**Service Bulletin No: 25-005****Ref No: 60****Modification No: EC-19-0147****ATA Chapter: 25****EQUIPMENT AND FURNISHINGS - STANDARD CABIN CONFIGURATION  
UPPER PANEL ASSEMBLY, EMERGENCY EXIT - REPLACEMENT OF THE GROMMETS****1. Planning information****A. Effectivity**

This Service Bulletin gives the data and instructions necessary to replace the grommets (P/N 944.87.32.001) with the new grommets (P/N 525.26.24.035).

Replacement of the grommets  
Figure 1

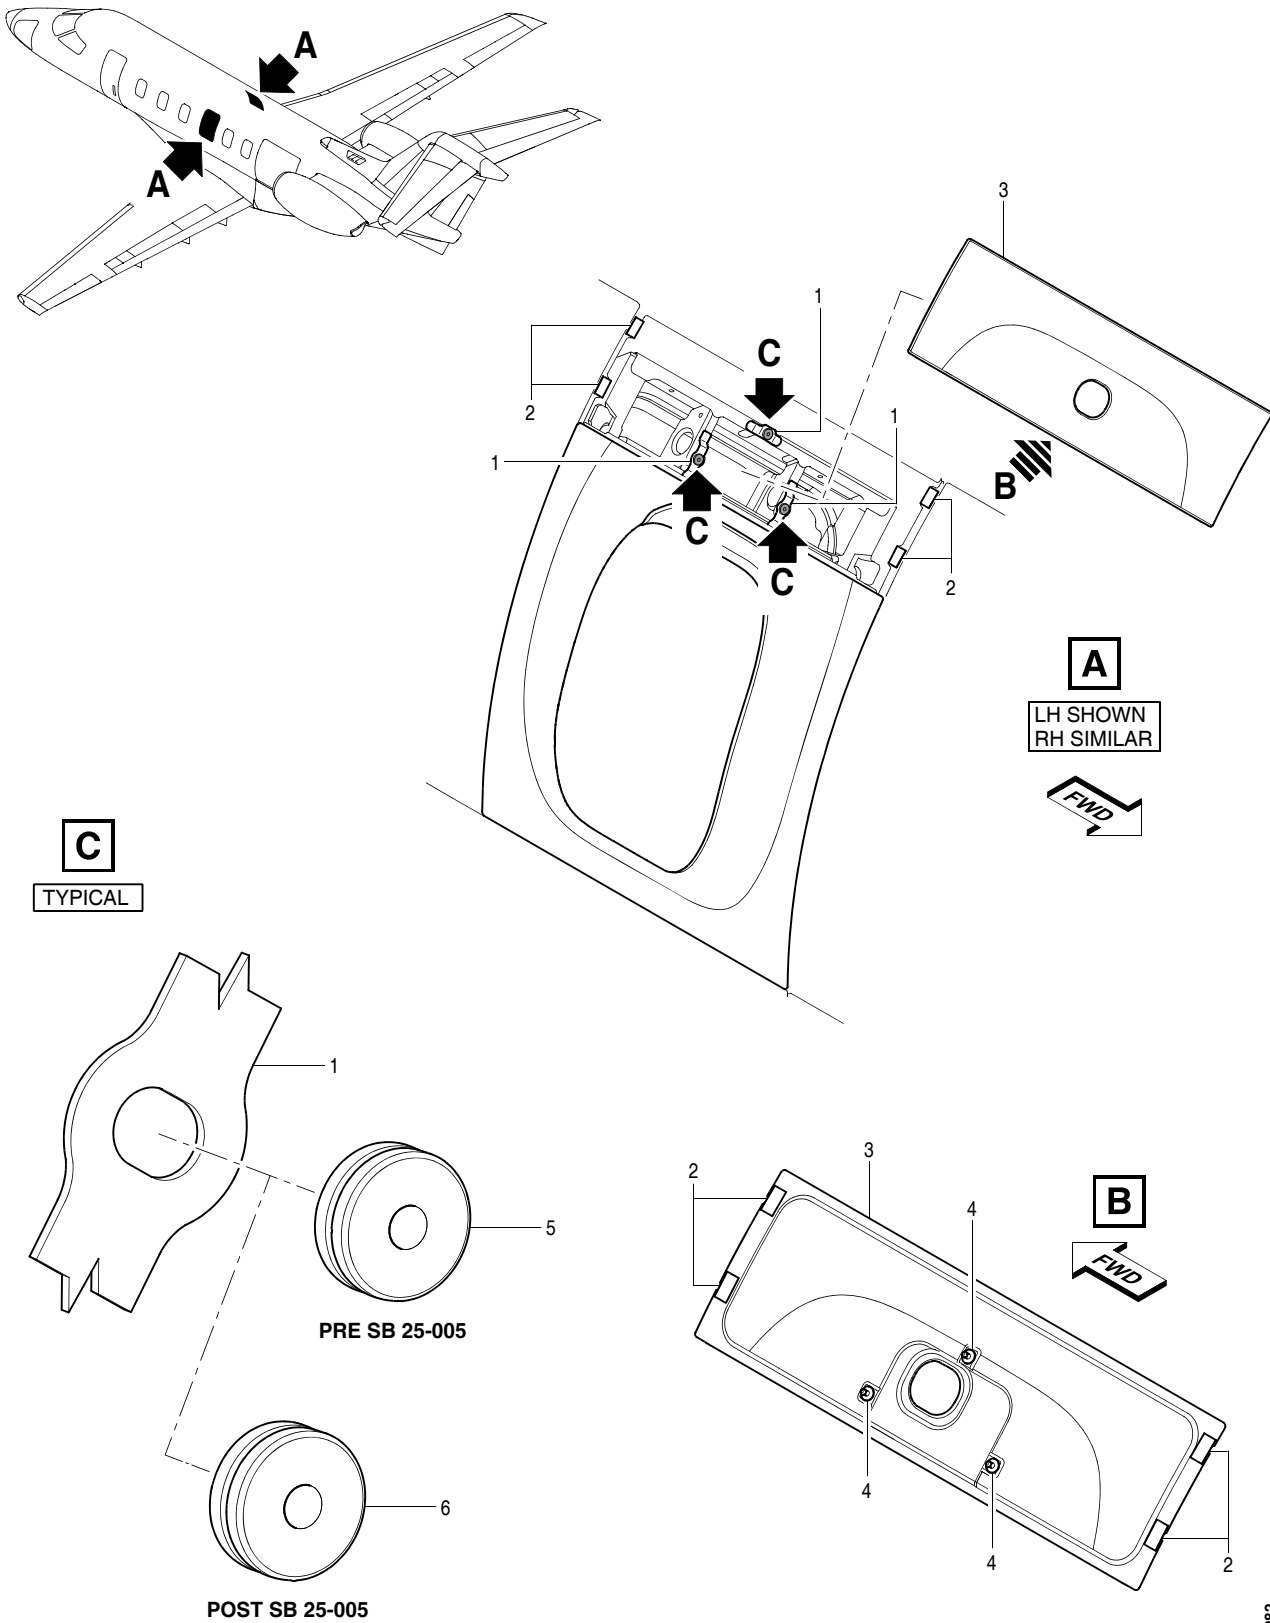
**B. Modification. Refer to Figure 1**

- (1) Release the two hook-and-loop tape fasteners (2) at the fwd and aft side of the upper panel assembly (3).
- (2) Pull the upper panel assembly (3) to disengage the three panel pins (4) from the grommets (5).
- (3) Remove the upper panel assembly (3).
- (4) Remove and discard the three grommets (5) (P/N 944.87.32.001) from the upper panel brackets (1).
- (5) Install the three new grommets (6) (P/N 525.26.24.035) on the upper panel brackets (1).
- (6) Apply a thin layer of grease (Material No. P04-030) to the three panel pins (4).

**CAUTION:** Make sure that you do not push the grommets through the brackets and into the structure when you install the upper panel assembly.

- (7) Put the upper panel assembly (3) in position and engage the three panel pins (4) with the grommets (6).
- (8) Make sure that the two hook-and-loop tape fasteners (2) at the fwd and aft side of the upper panel assembly (3) are attached.
- (9) Do the above procedure again to replace the three grommets (5), for the upper panel assembly (3), on the other side of the aircraft.
